SUBJECT: FORWARDING FIGURES AMENDING APPLICANT'S 04/04/77 PROPOSED MODIFICATION TO  
TECH SPEC FIGURE 2.1-1, RE-REACTOR CORE THERMAL AND HYDRAULIC SAFETY  
LIMITS... NOTARIZED 06/22/78

PLANT NAME: TURKEY PT #3  
TURKEY PT #4

June 22, 1978  
L-78-217

Re: Turkey Point Units 3 and 4  
Docket Nos. 50-250 and 50-251  
Thermal and Hydraulic Safety Limits

Figure 2.1-1. Reactor Core Thermal and Hydraulic Safety Limits, 3 Loop Operation

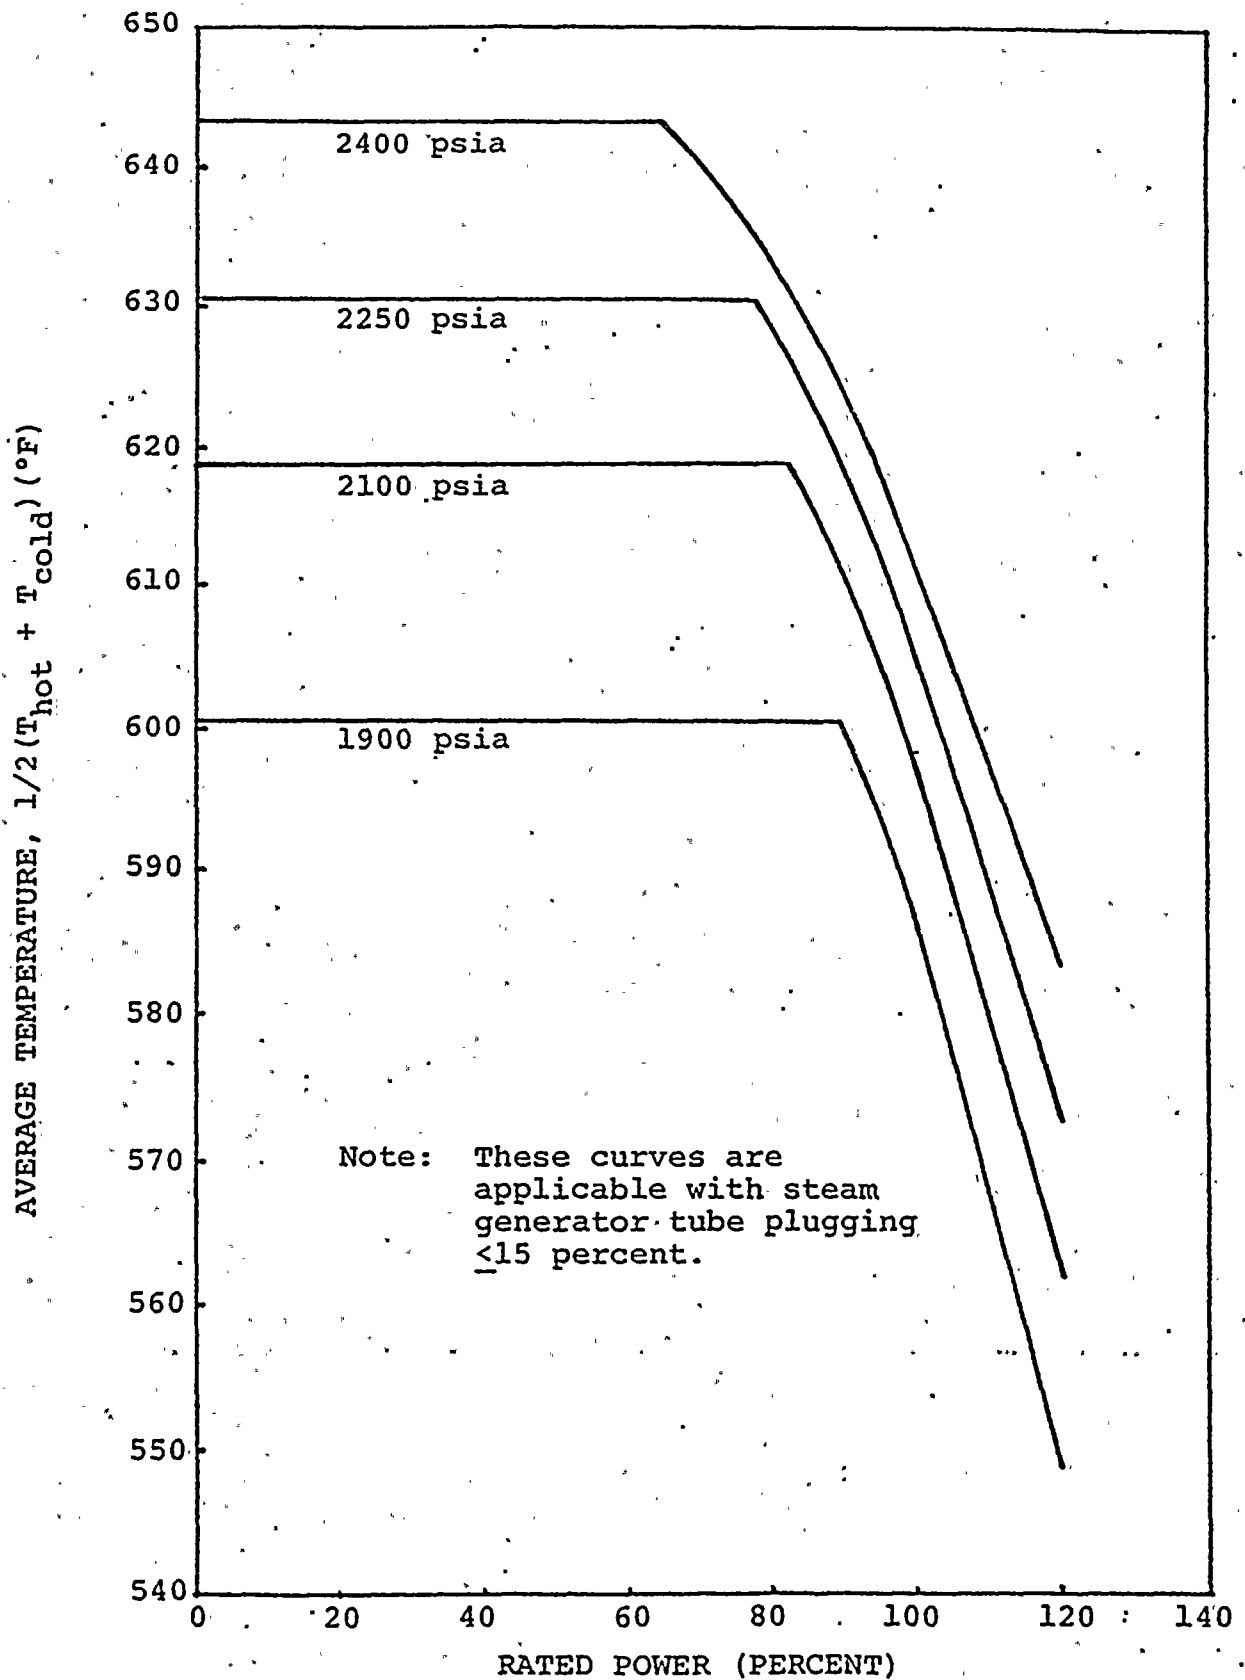
On April 4, 1977, (L-77-106), Florida Power & Light Company submitted proposed modifications to Technical Specification Figure 2.1-1, Reactor Core Thermal and Hydraulic Safety Limits, Three Loop Operation. The revised figure included the effects of rod bow. This figure has subsequently been revised as a result of steam generator tube plugging. The attached figures are submitted as an amendment to our April 4, 1977 submittal. Figure 2.1-1 is for operation with  $\leq 15$  percent steam generator tubes plugged and Figure 2.1-1a is for operation with  $\geq 15$  percent and  $\leq 19$  percent steam generator tubes plugged. Both figures include a rod bow penalty consistent with our April 4, 1977 submittal.
